Los Angeles Regional Water Quality Control Board

SUBJECT: REVIEW OF DRAFT REMEDIAL ACTION PLAN; CLEANUP AND ABATEMENT ORDER NO. R4-2021-0079 AMENDMENT

SITE: SKYPARK COMMERCIAL PROPERTIES (ASSESSOR PARCEL NO. 7377-006-906), 24701 – 24777 CRENSHAW BOULEVARD AND 2530, 2540, AND 2600 SKYPARK DRIVE, TORRANCE, CALIFORNIA (SCP NO. 1499, GLOBAL ID NO. T10000014333)

Attachment 5 - Figure 23 – Proposed Groundwater Sampling Locations, Regional Groundwater Remediation Area, Vadose Zone, and Perched Groundwater Remediation Areas

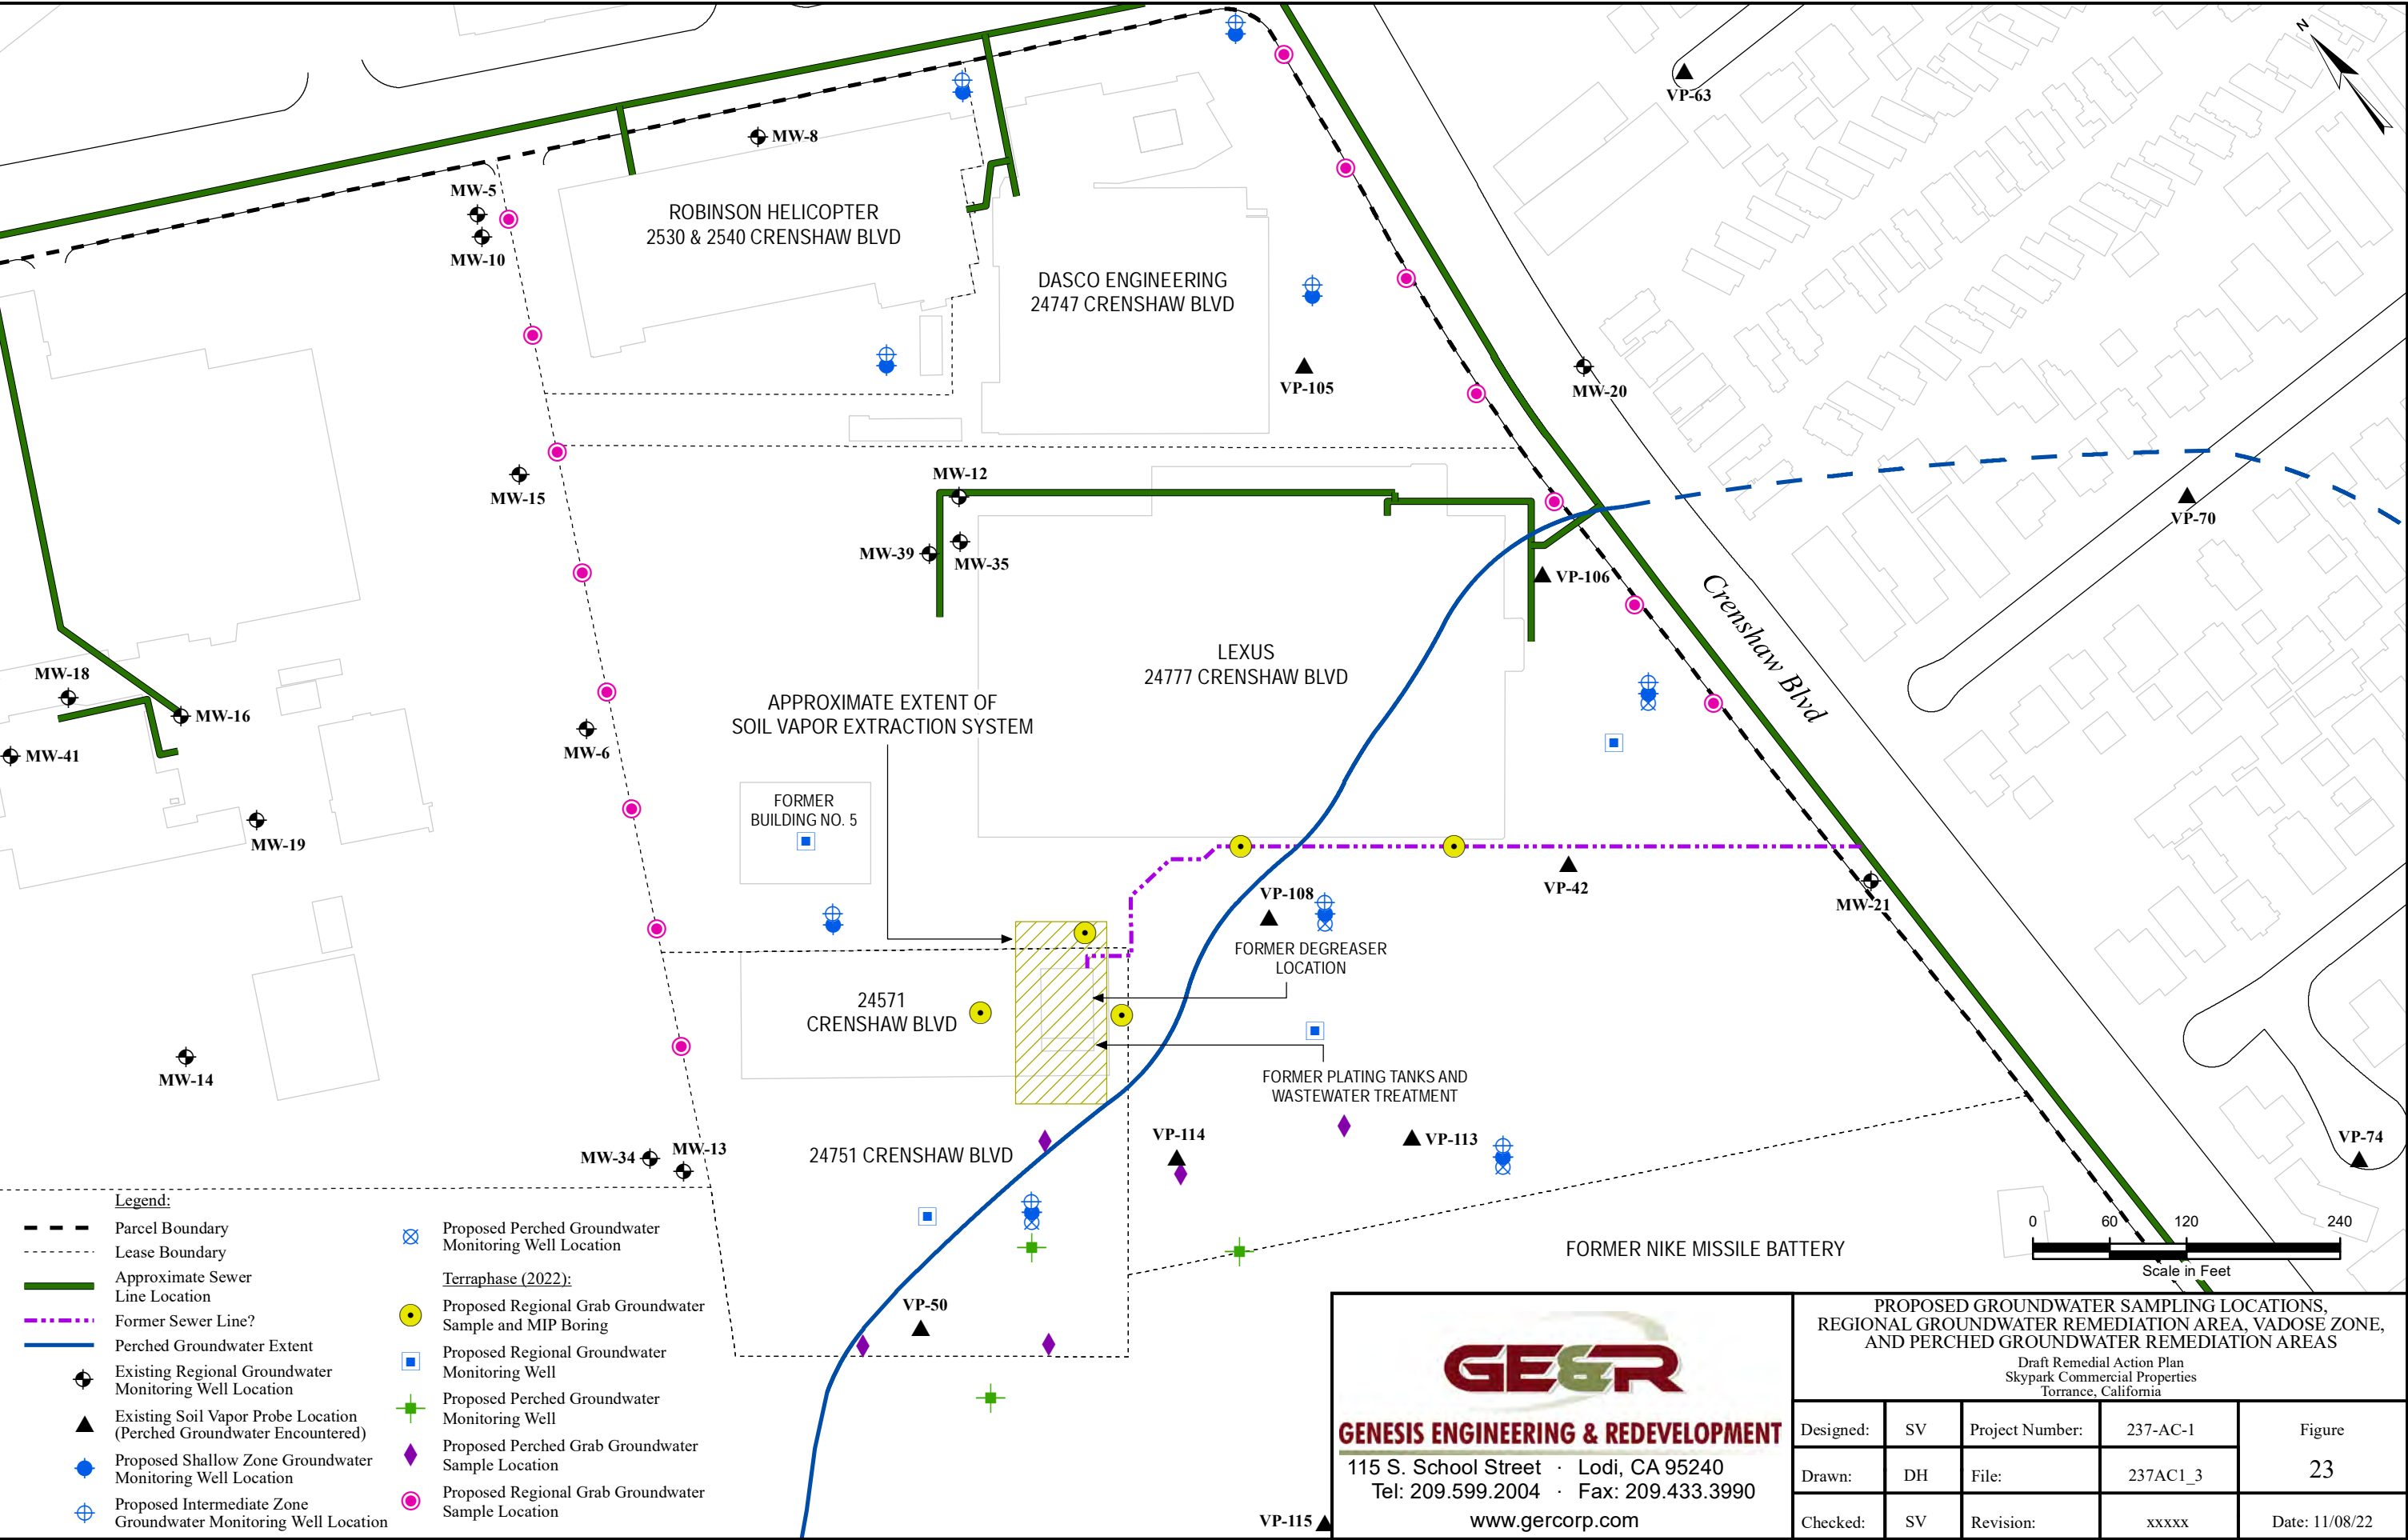
4. Perched and Regional Groundwater
 - a. Install five additional locations of clustered perched and regional (shallow and intermediate groundwater zones) groundwater monitoring wells on Property 1 of EA Properties in lieu of well locations proposed in the investigative component of the Revised EAP IRAP, as shown in Attachment 5, *Figure 23 – Proposed Groundwater Sampling Locations, Regional Groundwater Remediation Area, Vadose Zone, and Perched Groundwater Remediation Areas* (Figure 23).

- b. Install four locations of clustered shallow and intermediate groundwater zone monitoring wells on Properties 2 and 3 of EA Properties, as shown in Figure 23.

8. The Los Angeles Water Board conditionally approves the proposed scope of work for the assessment of the perched and regional (shallow and intermediate groundwater zones) groundwater beneath the EA Properties with the following comments and requirements:

- a. Los Angeles Water Board staff recognizes the potential duplication of efforts between portions of the conditionally approved investigative component of the Revised EAP IRAP and the proposed scope of work in the Draft RAP. The following modifications and integrations should be made:

Attachment 6 - Figure 24 – Proposed Groundwater Monitoring Wells on the Southern Plume Boundary

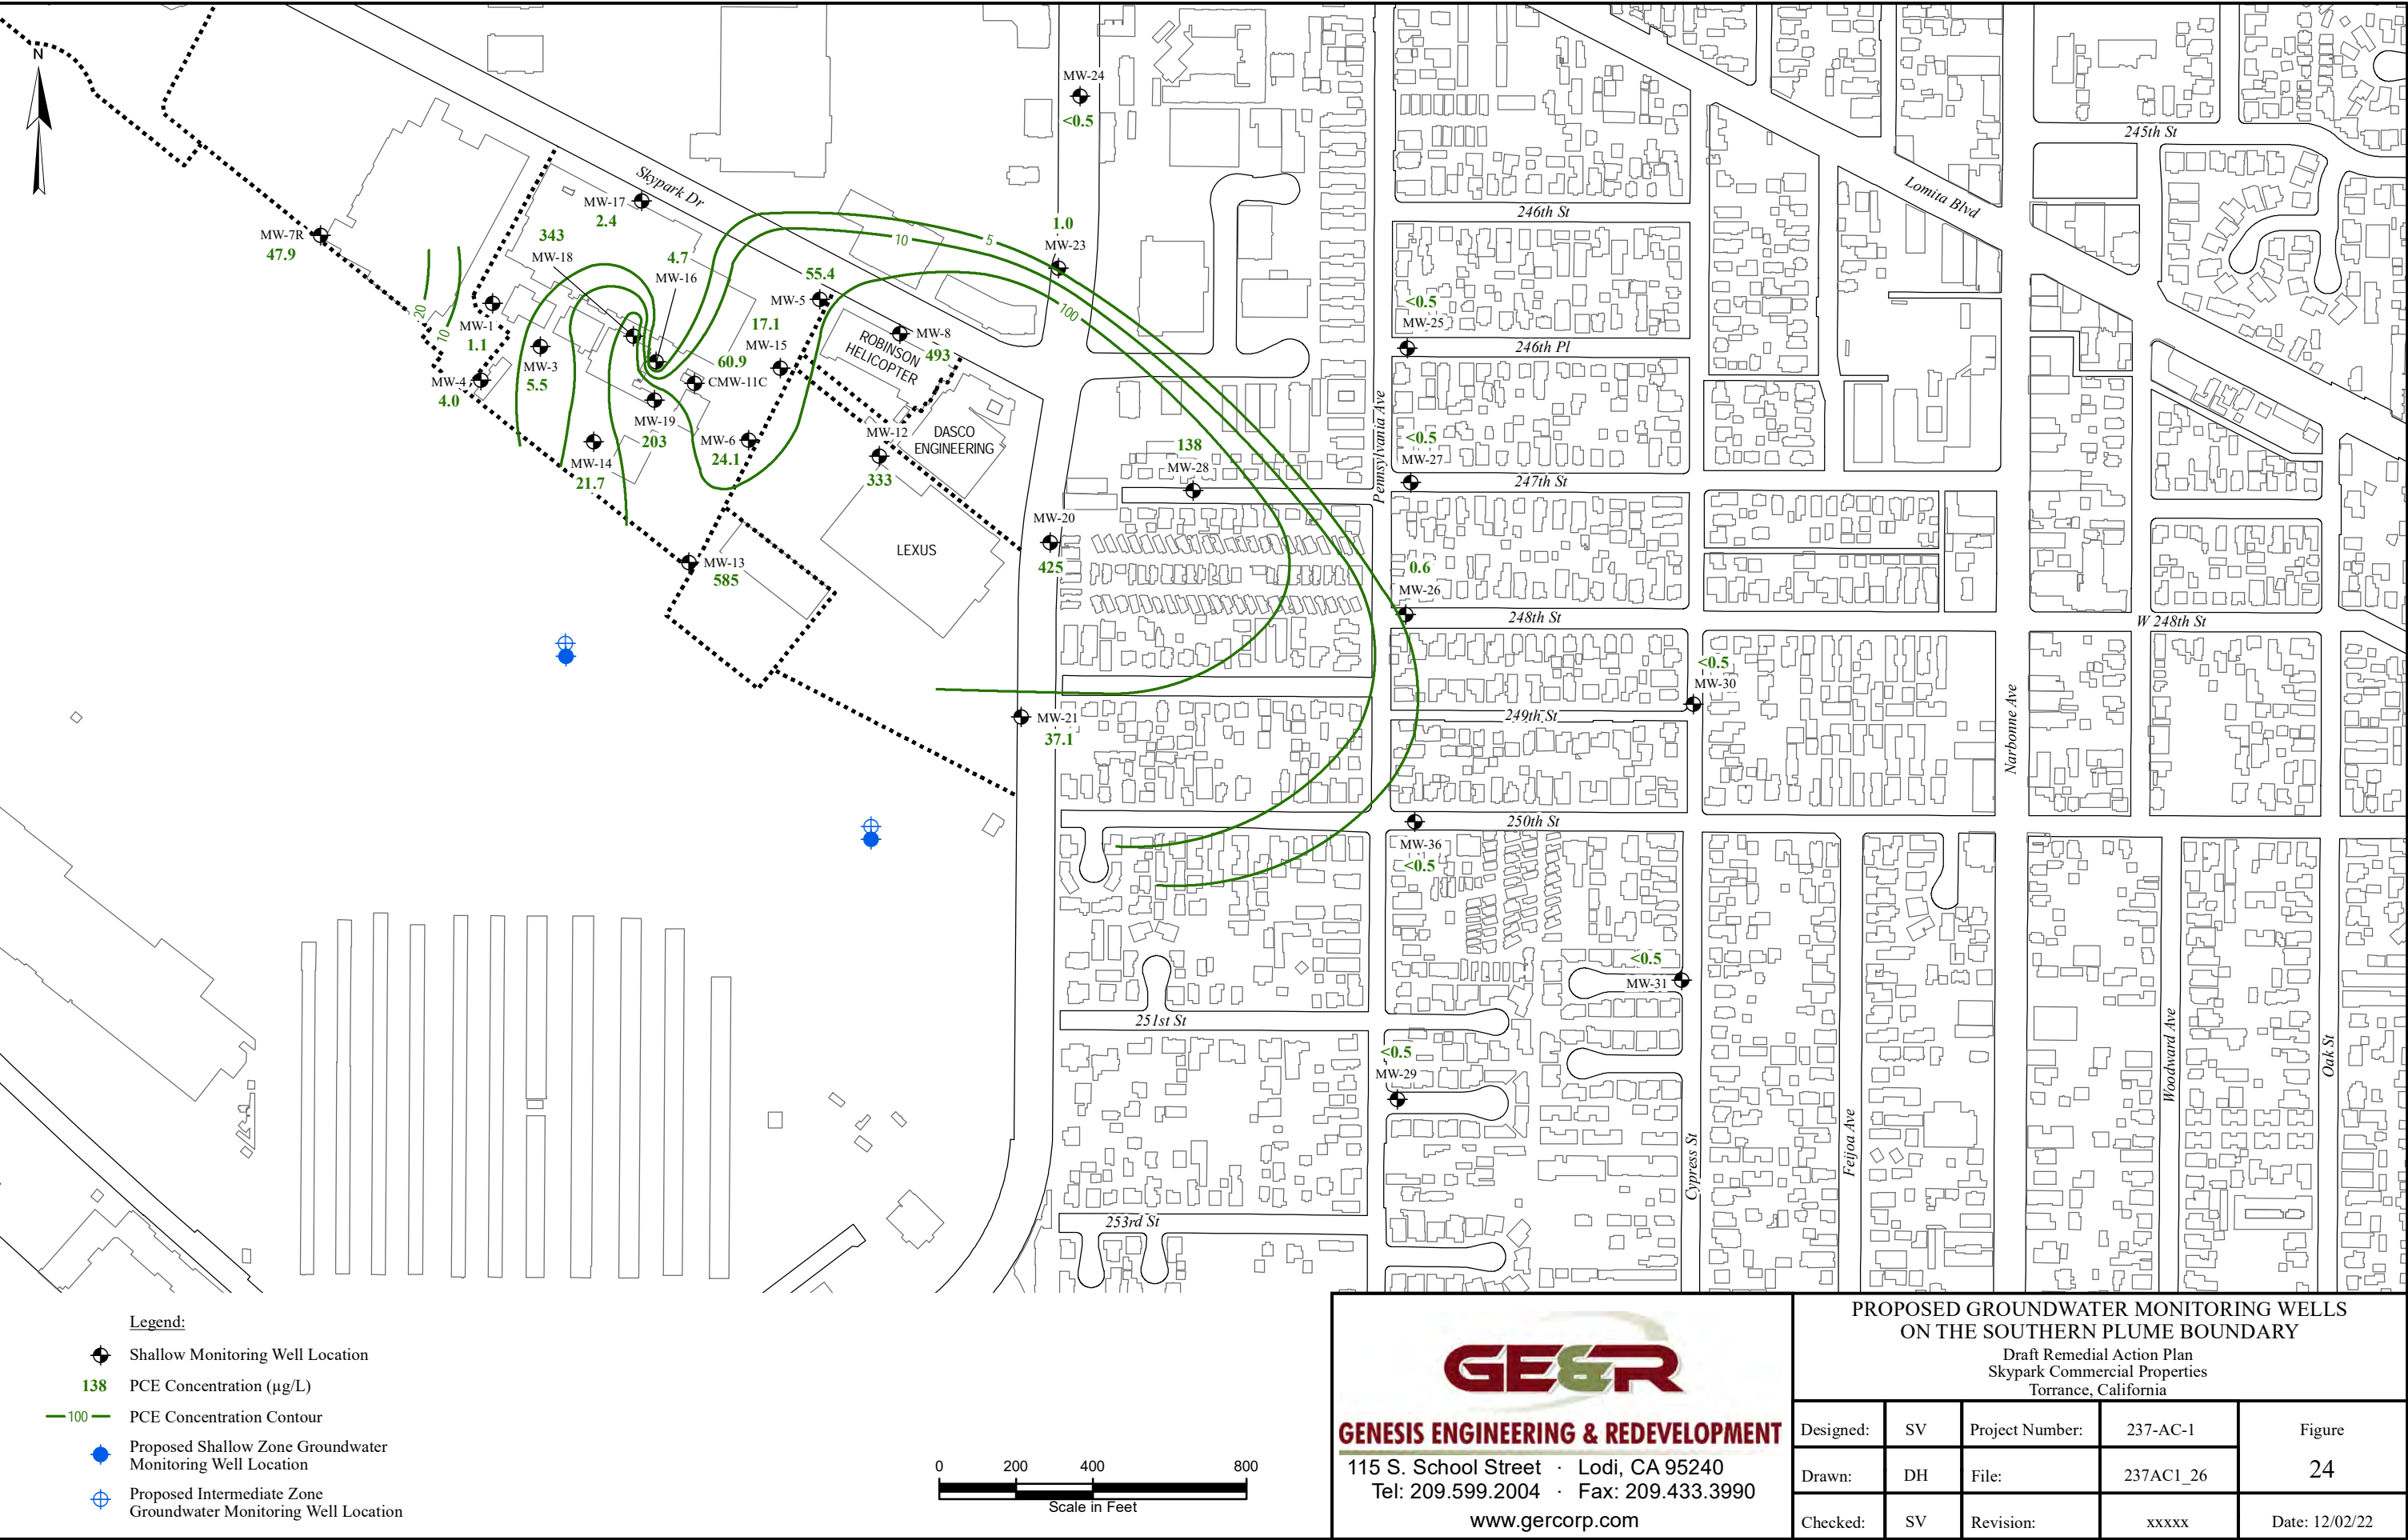
9. The proposed scope of work to delineate regional (shallow and intermediate) groundwater, and perched groundwater where present, south of the Site and beneath the Torrance Airport, as shown in Figure 24, is approved. Submit a report, at a minimum documenting the installation of groundwater monitoring wells, field observations, laboratory data, conclusions, and recommendations. Task 3.a. – Site Assessment (i.e., vertical and lateral delineation) of the Order is the underlying requirement of this proposed scope of work.
